SERVICE LETTER

No. 836

Piper Aircraft Corporation

Subject: Narco ADF 140/141 Antenna Inspection and Modification

FIGURE 1 - Terminal Board Prior to Modification

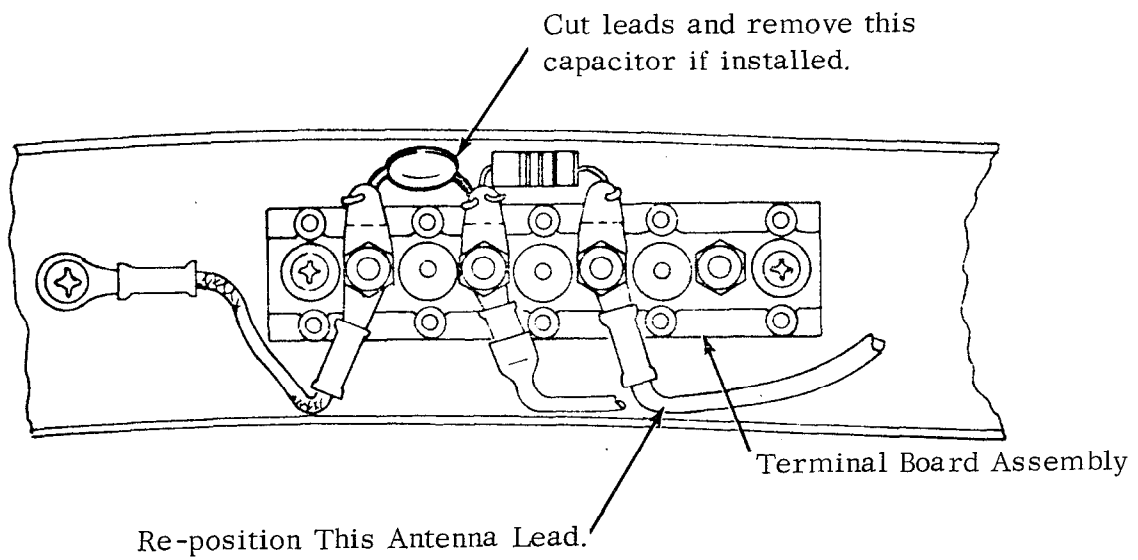
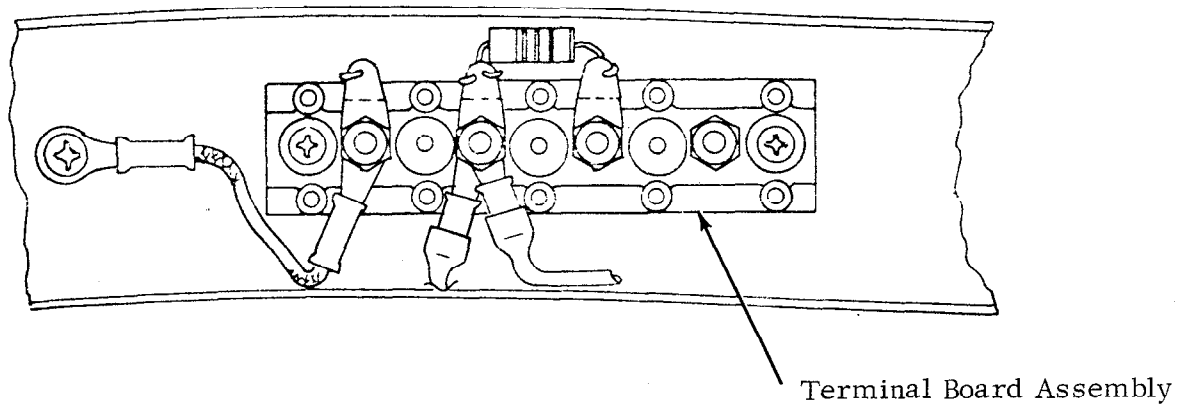
1. Insure the aircraft is equipped with a Narco ADF-140/141 receiver.
2. Remove top overhead speaker panel to gain access to the terminal block connections from the sense antenna lead in.
3. Inspect antenna terminal board for position of antenna lead attachment and presence of capacitor (if installed); referenced attached sketch fig. 1.

4. Re-position antenna leads to common pin and remove capacitor (if installed); reference attached sketch fig. 2.
5. Re-install overhead speaker panel (removed in Step 2, above).
6. Make appropriate log book entry.
